**CONSTRUCTION BULLETIN
No. 002**

**Institution: California Institution for Men (CIM)
Project Name: Replace Roofs Phase 1
Construction Bulletin Number: 002
Date of Issuance: February 6, 2026**

Description: This Bulletin makes modifications and corrections to the Project Manual and Drawings as described below.

DATE: 11/03/2025
SHEET NUMBER
A2.6
16 OF 80 SHEETS V1

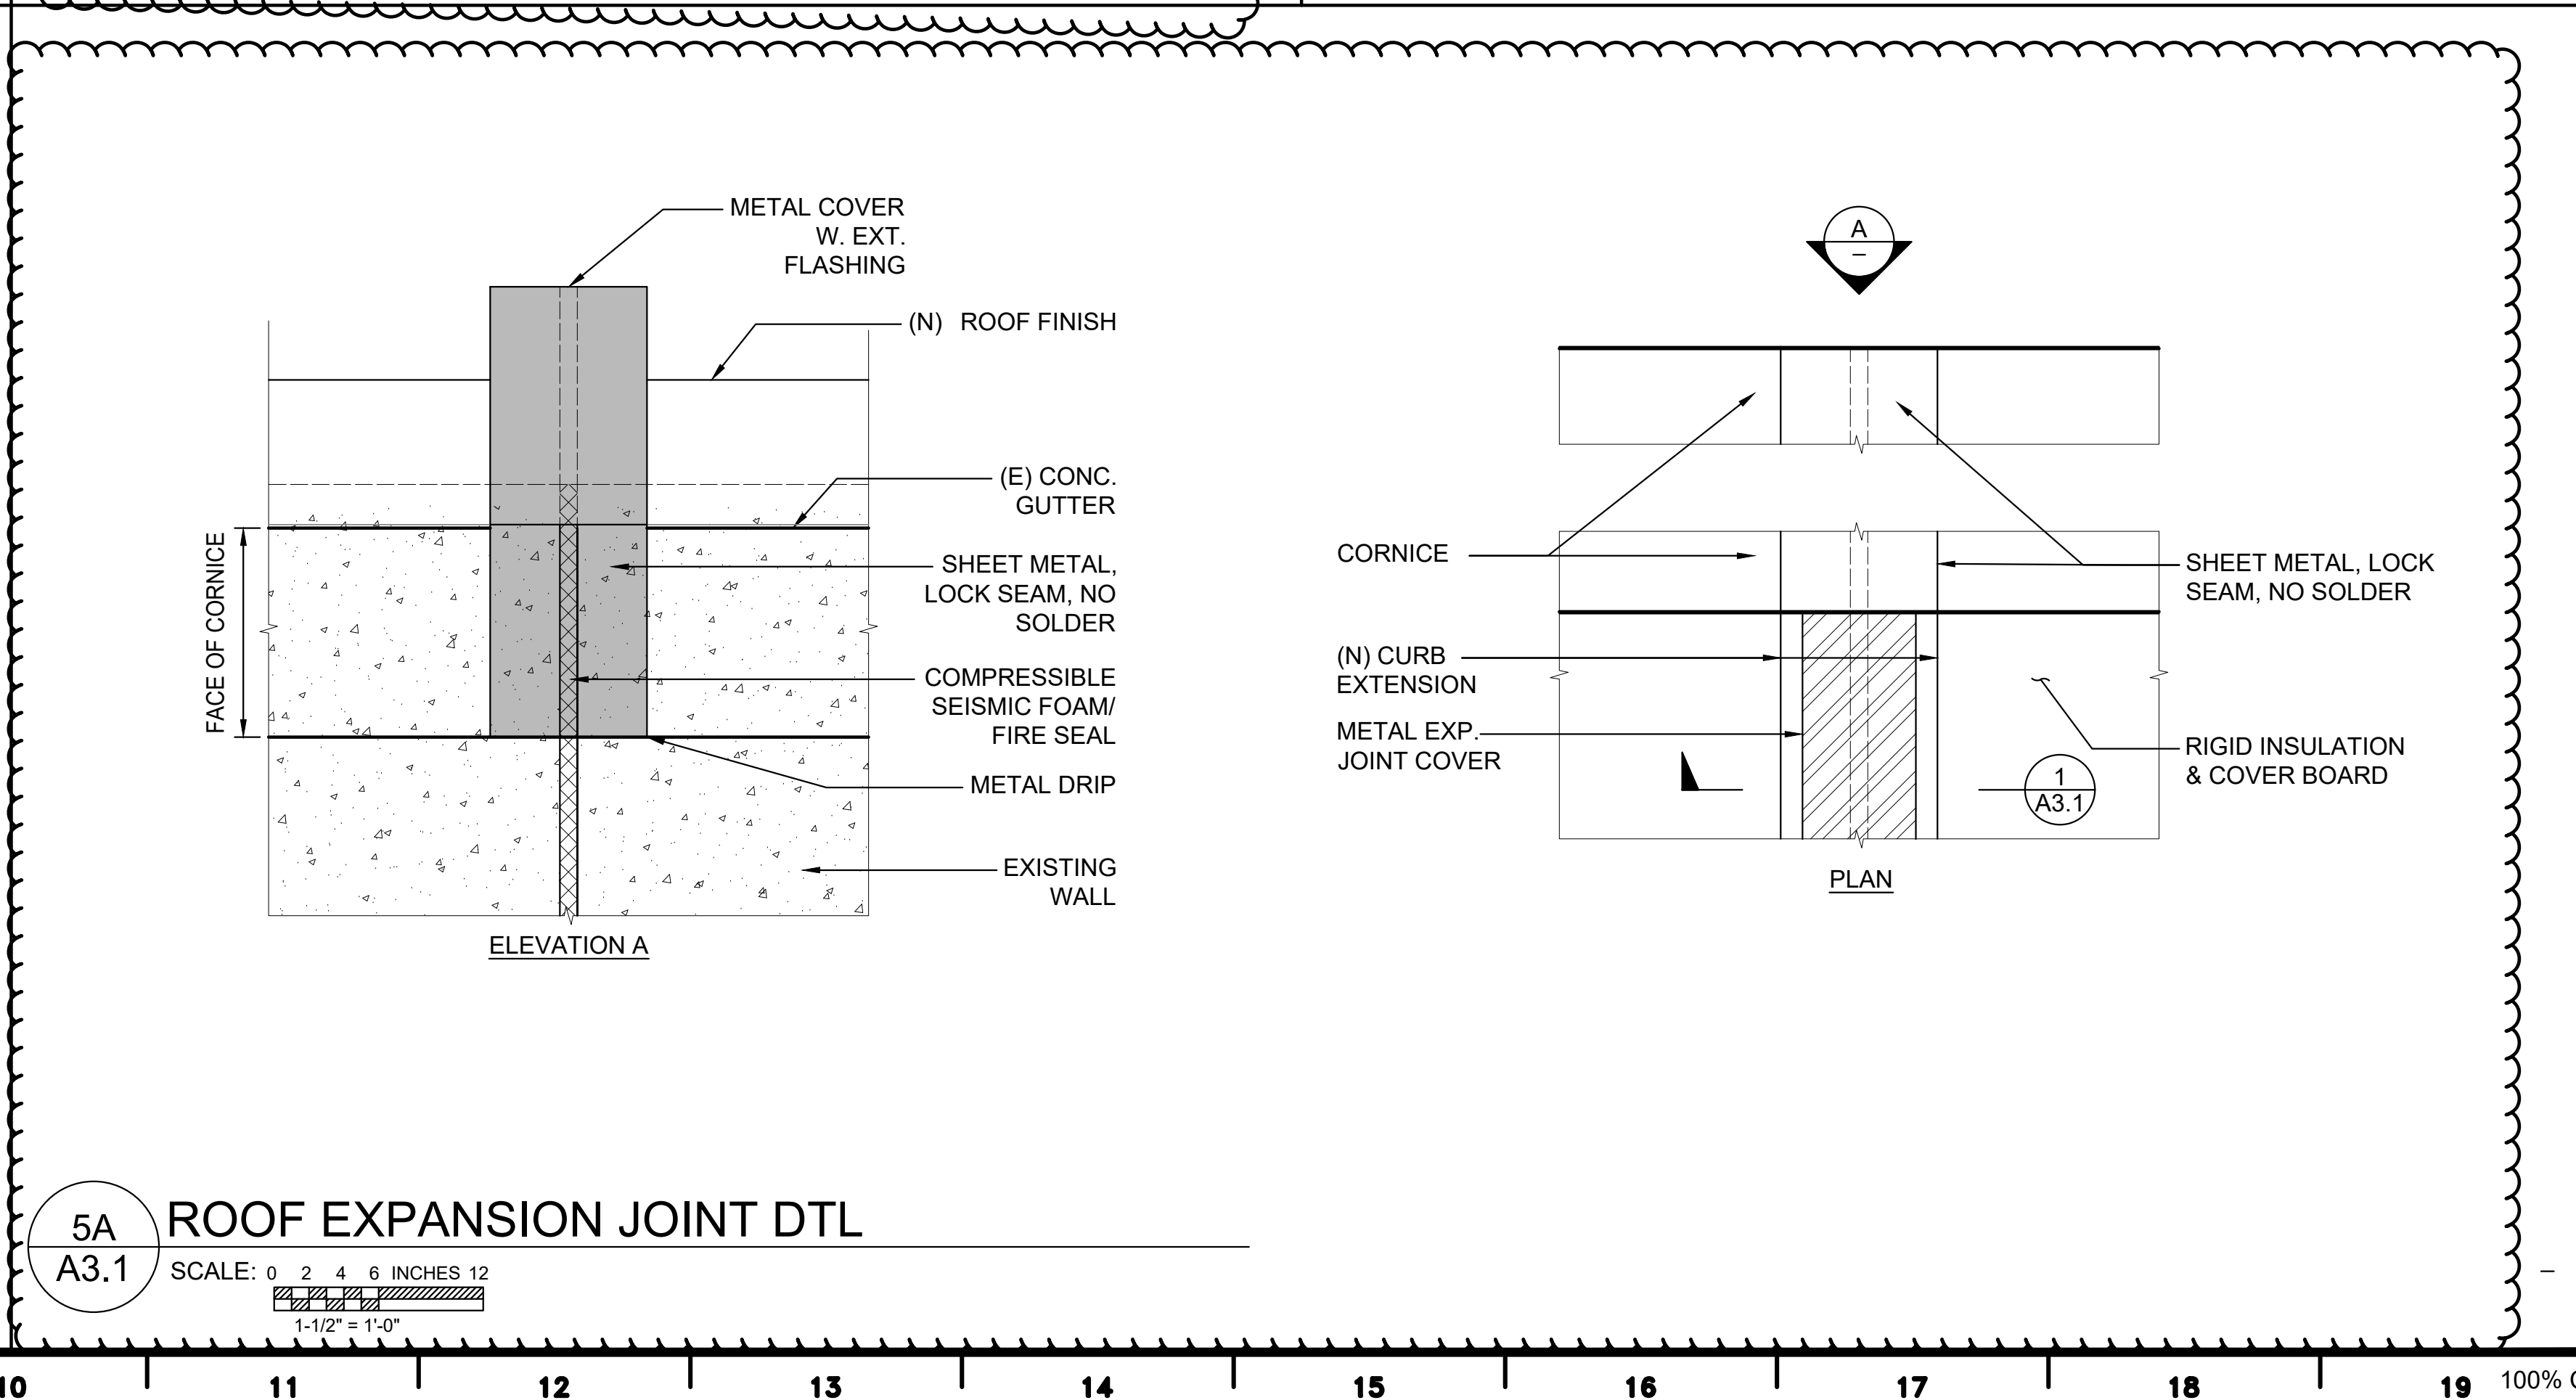
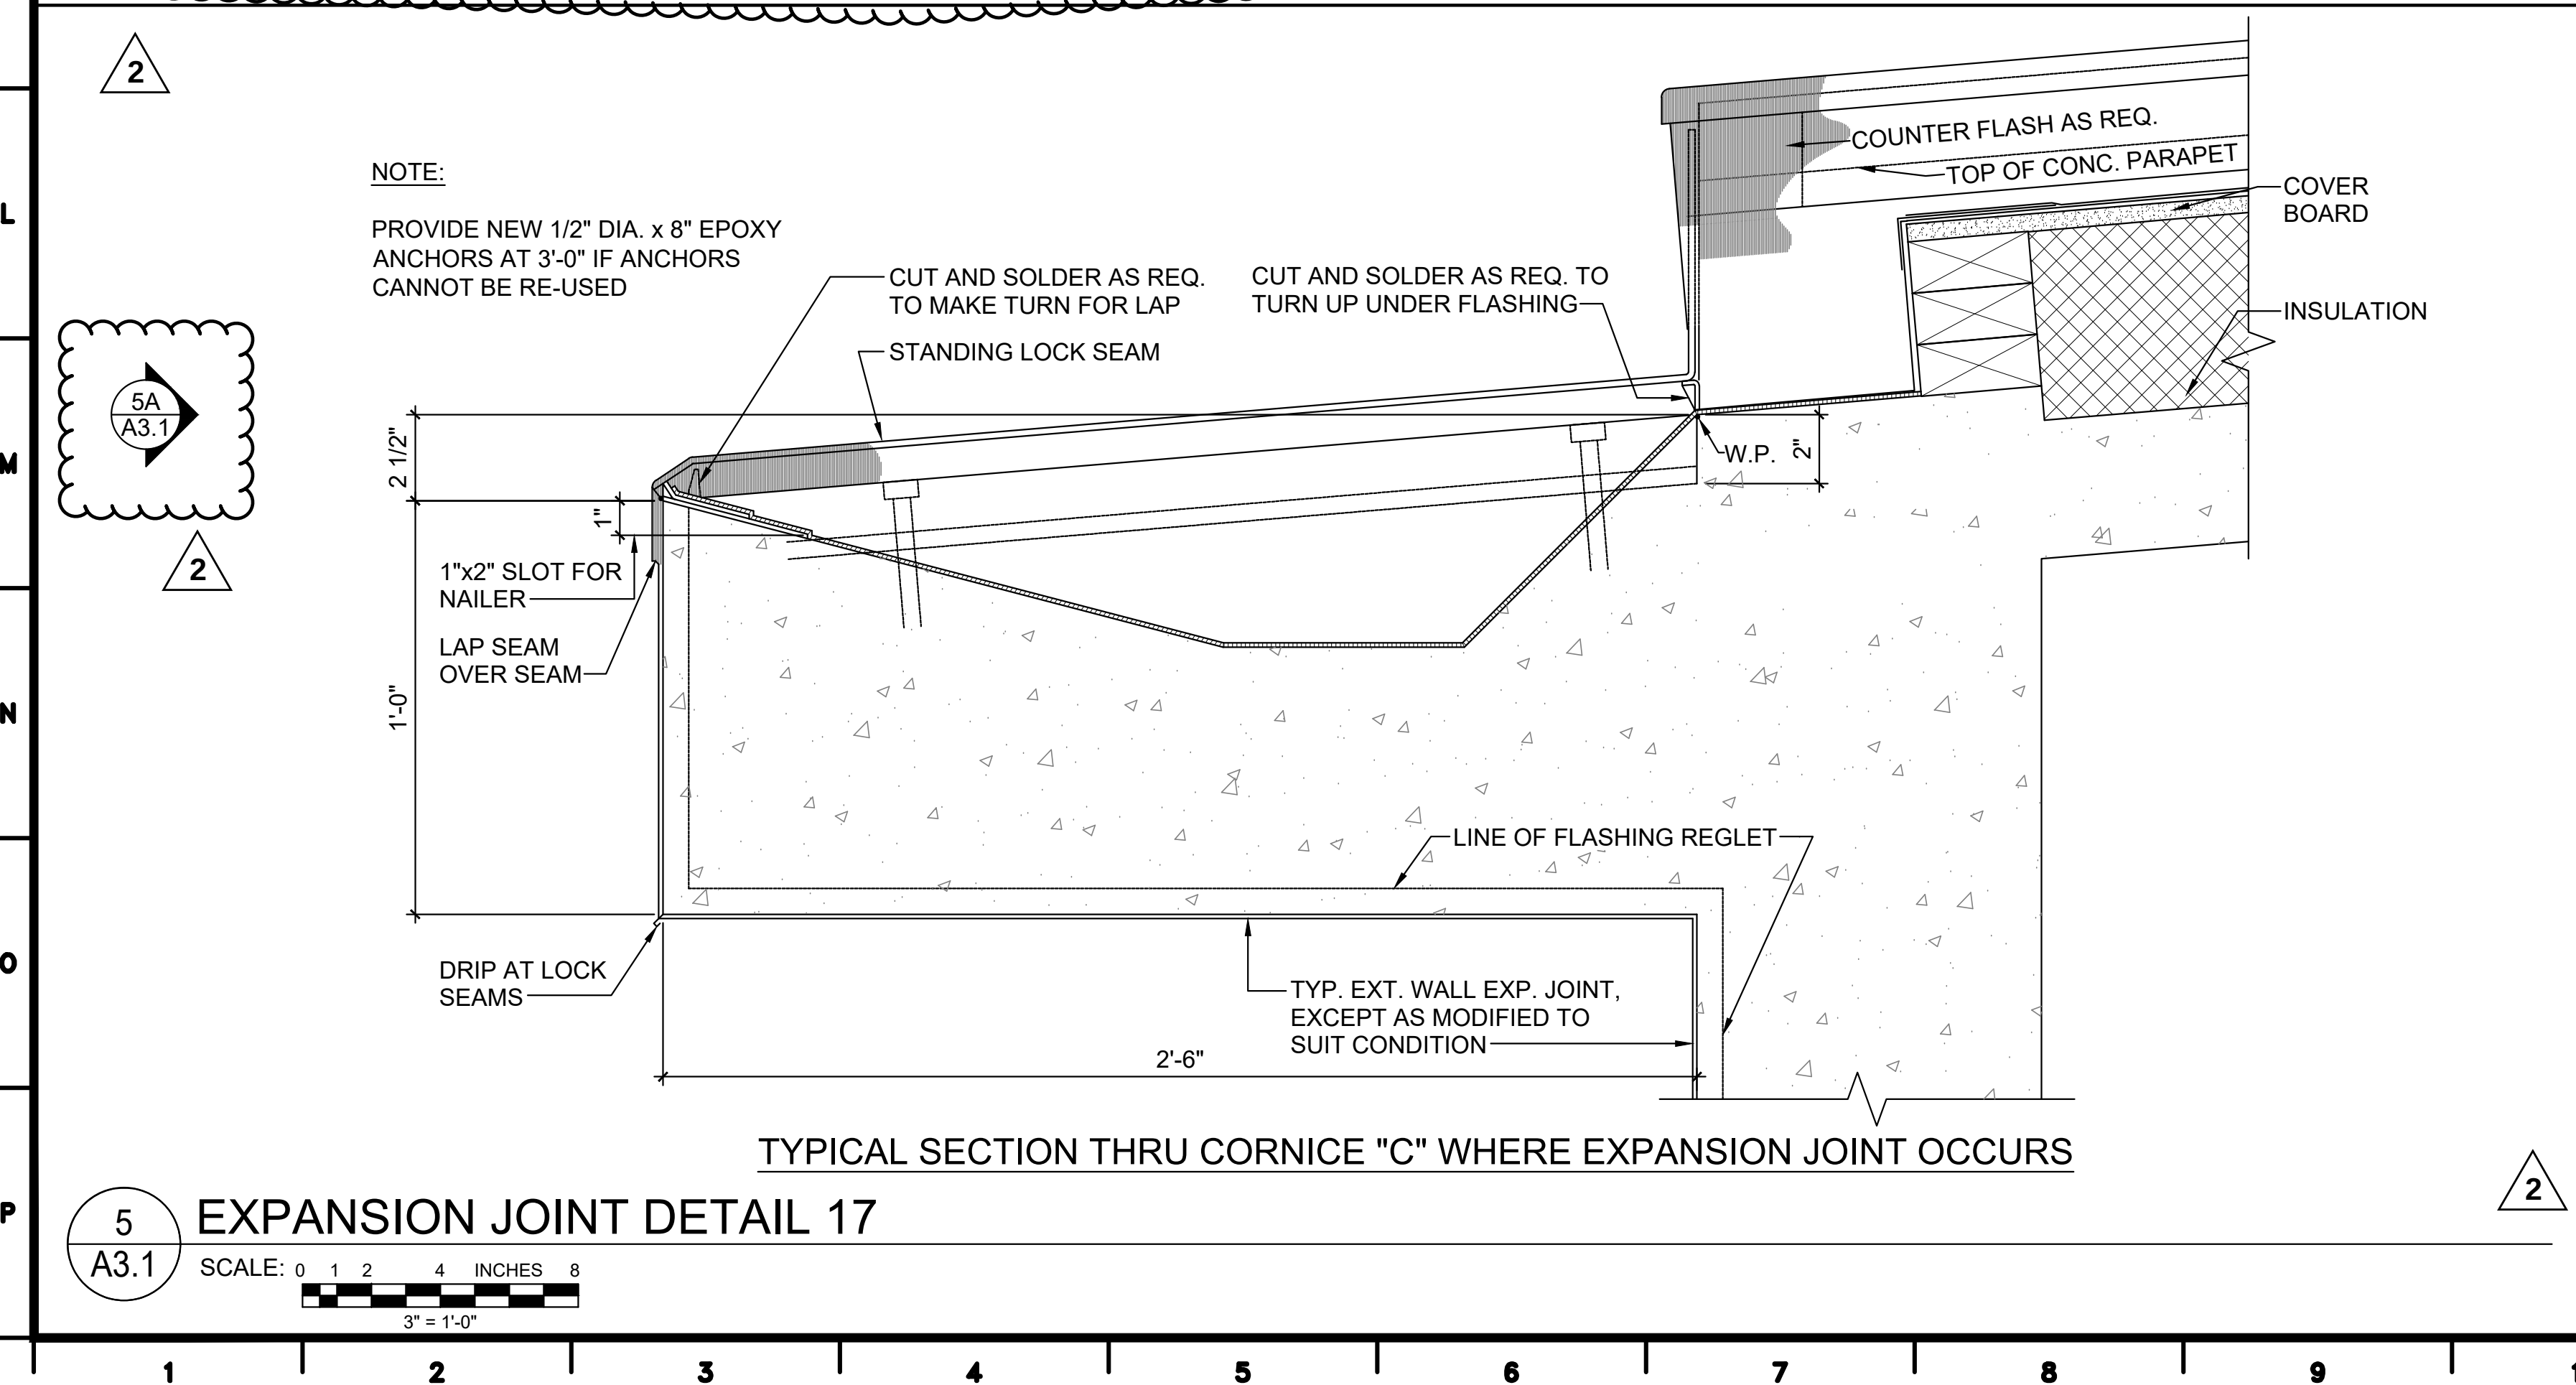
- tt. **Add** tag for DETAIL 7/A3.7
 - uu. **Change** tag for DETAIL from 2/A3.6 to 7/A3.7
6. Sheet A2.6 – UNIT 2 –ROOF NEW WORK PLAN
- a. **Add** NEW WORK KEYNOTE 16 reading PVC ROOFING WITH XPS TAPER INSULATION AT MECHANICAL PENTHOUSE SEE SHEETS A3.11 & A3.1

- b. **Add** NEW WORK KEYNOTE 17 reading REINSTALL (E) CAST-IRON DOME STRAINER AT (E) ROOF DRAIN
 - c. **Remove** LEGEND information regarding ELEVATION DATUM

- d. **Change** roof slope from 1:12 to 1/2:12
 - e. **Change** roof slope from 1/4:12 to 1/2:12
 - f. **Change** Roof Slope from 3/8:12 to 1/2:12
 - g. **Change** roof slope from 3/8:12 to 1/2:12

- h. **Change** roof slope from 3/8:12 to 1/2:12
 - i. **Change** roof slope from 7/8:12 to 3/4:12
 - j. **Change** roof slope from 7/8:12 to 3/4:12
 - k. **Change** roof slope from 7/8:12 to 3/4:12

- l. **Change** roof slope from 1 1/8":12 to 1:12
 - m. **Remove** roof slope 1/8:12

- n. **Remove** roof slope 1/8:12
- o. **Remove** roof slope 1/8:12
- p. **Remove** roof slope 1/4:12
- q. **Change** Roof Slope from 3/8:12 to 1/2:12
- r. **Change** tag for DETAIL from 2/A3.6 to 1/A3.5

- s. **Change** tag for DETAIL from 2/A3.6 to 1/A3.5
- t. **Change** NEW WORK KEYNOTE tag from 2 to 9
- u. **Change** NEW WORK KEYNOTE tag from 2 to 9
- v. **Change** tags for DETAILS from 2/A3.6 and 7/A3.7 to 6/A3.7 and 1/A3.5

- w. **Change** tag for DETAIL from 7/A3.7 to 6/A3.7
- x. **Add** cricket at exhaust fan
- y. **Add** NEW WORK KEYNOTE tag 8 at roof drain
- z. **Relocate** NEW WORK KEYNOTE tag 2

- aa. **Add** Mechanical Penthouse roof to scope of work.
 - 1) **Add** roof slopes
 - 2) **Add** dimensions
 - 3) **Add** NEW WORK KEYNOTE tag 16
 - 4) **Add** tag for DETAIL 3/A3.11

- 5) **Add** tag for DETAIL 2/A3.11
 - 6) **Add** tag for DETAIL 6/A3.11
 - 7) **Add** tag for DETAIL 7/A3.11
